British Kart  
Championships

**Shenington 21 – 23 July 2023.**

**Event Bulletin 07 – Technical IAME**

**Alternative Rain Cover IAME X30 Junior & Senior**

RAIN COVER FOR ALTERNATIVE INLET SILENCER – DRAWING

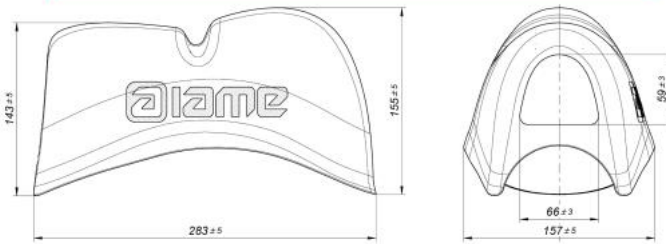
In addition to the above inlet silencer there is an option to use an alternative component the details of which are listed below.

IAME UK have confirmed that with immediate effect the old unit has now been discontinued and replaced with the item below - see page 2:

THIS RAIN COVER TO USE ONLY FOR ALTERNATIVE INLET SILENCER  
(Appendix 21)
